DESCRIPTIVE REPORT

Office No. H-10134

General Locality Penobscot River

Locality Orland River to Fort

AWOIS Item
No. 03017

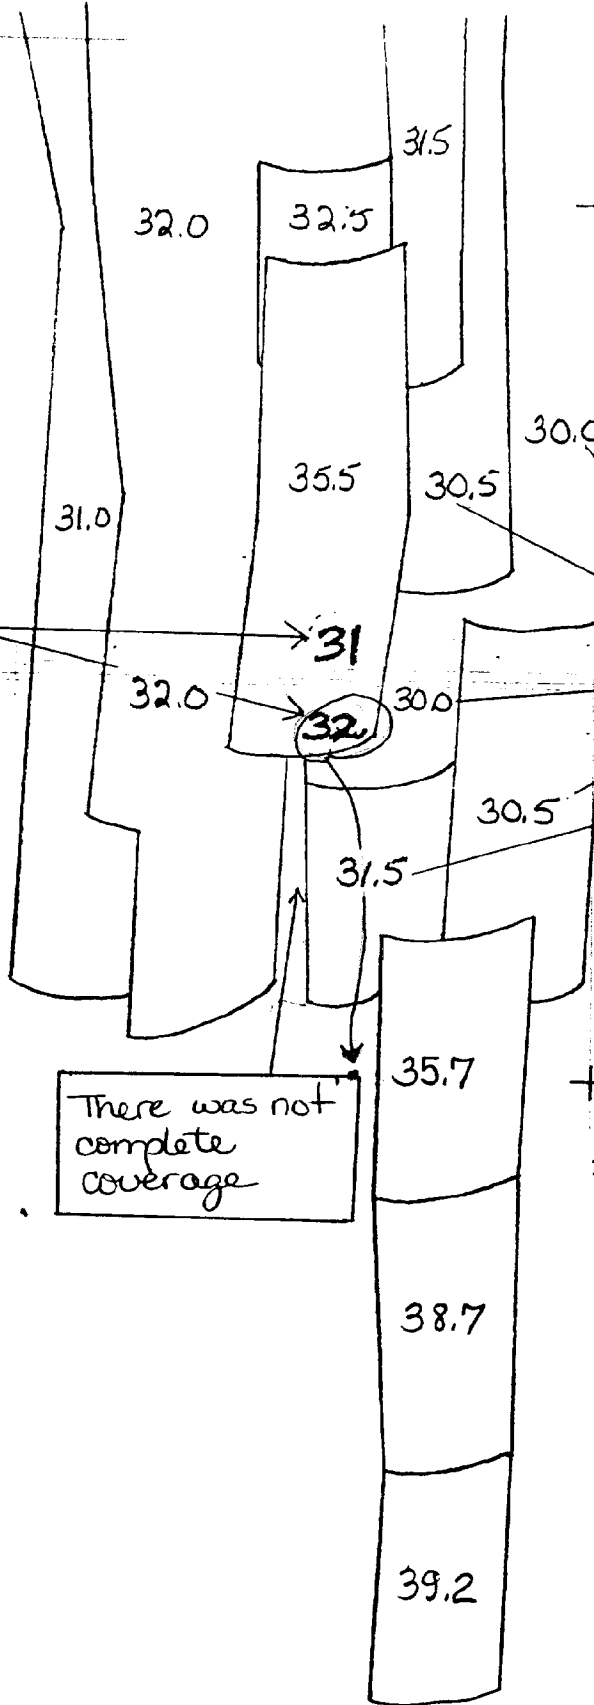
Effective depth
is not deep
enough to find
depths of
31 and 32 feet

ODOM LEDGE

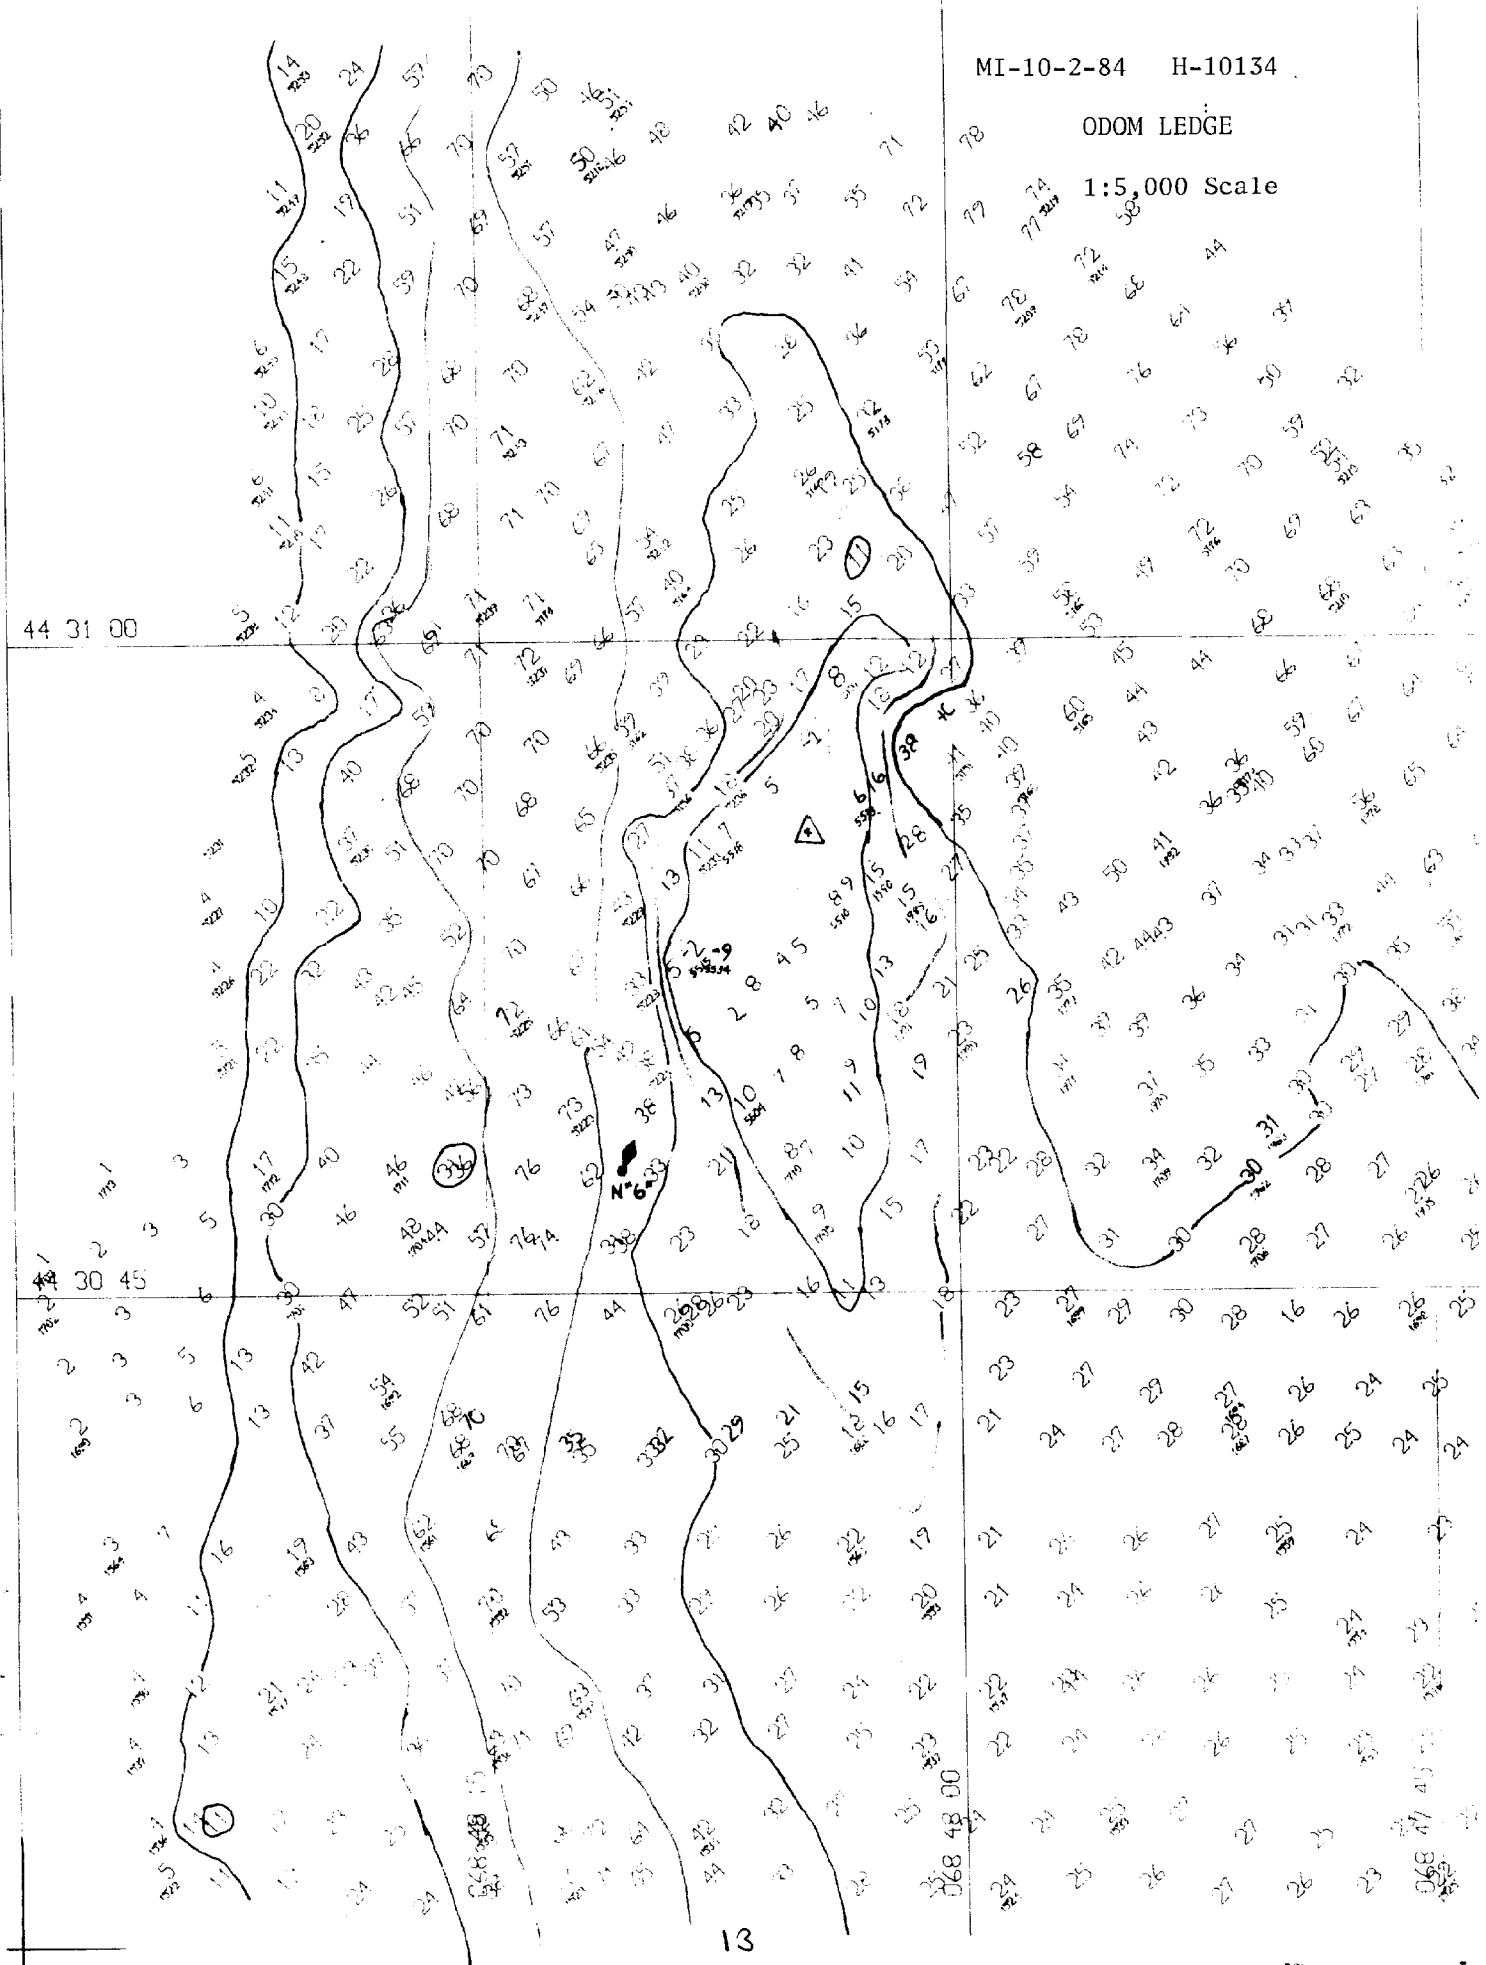
It is recommended that the previously charted 31 foot depth be removed, and the above two submerged pilings be added as shown on the final field sheet in red ink.
